ADDENDUM NO. 1

**LOWELL HIGH SCHOOL OLD POOL INFILL
AND RELATED WORK
Lowell, IN 46356**

ADDENDUM ONE

Addendum One (AD.01) to the drawings and specifications prepared by Gibraltar Design for **Lowell High School Old Pool Infill and Related Work** for Tri-Creek School Corporation, Lowell, Indiana.

2/4/2026 3:03:44 PM
C:\Users\bdumstra\OneDrive - Millies Engineering Group\Documents\MEG_Lowell HS Old Pool Infill_MEP-R25_bduinstra.rvt

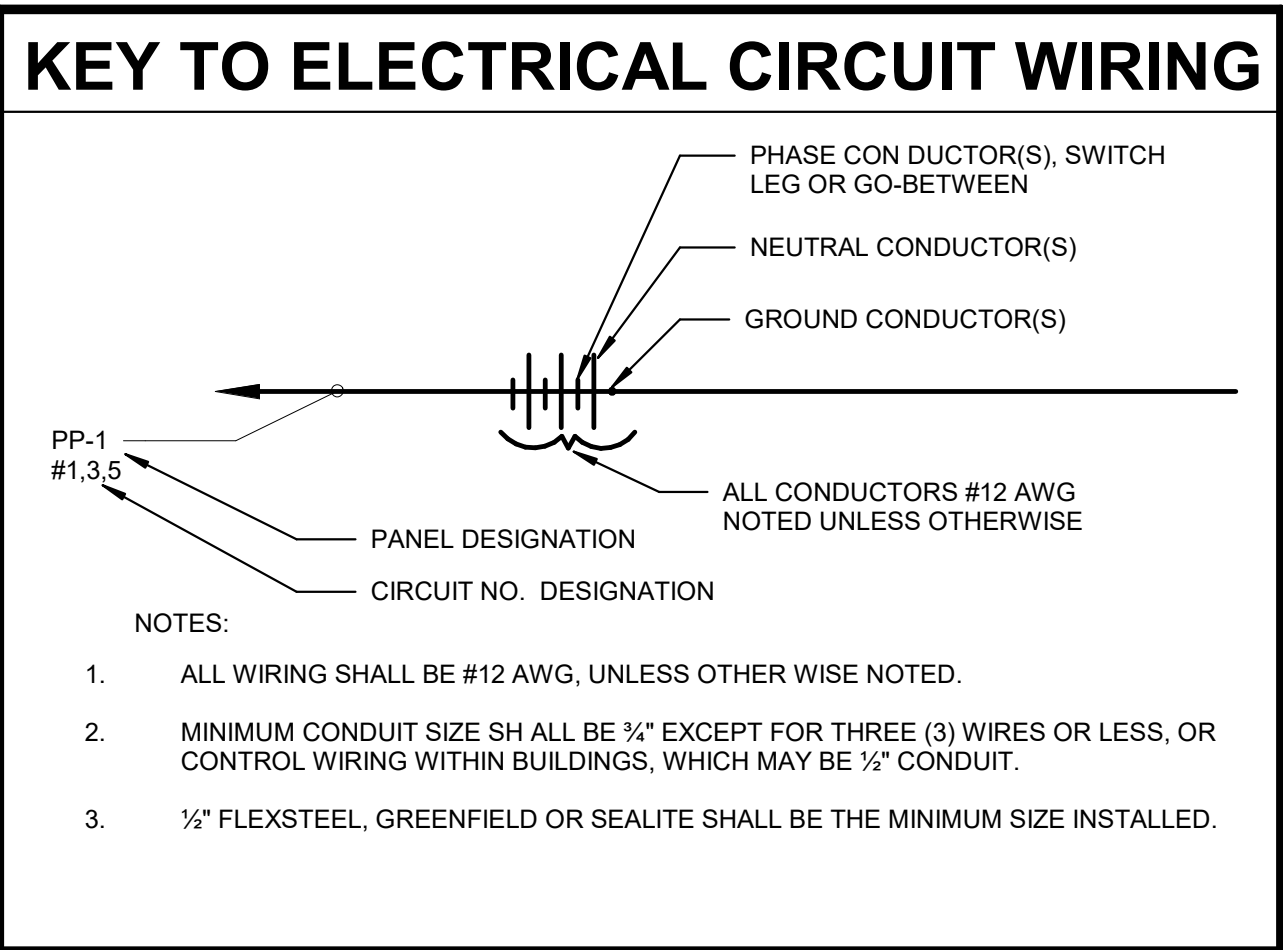
6. Sheet E-601

A. Refer to revised full size drawing included in this Addendum for the following revisions:

1. Added fixture P-2 to Interior Lighting Fixture Schedule.
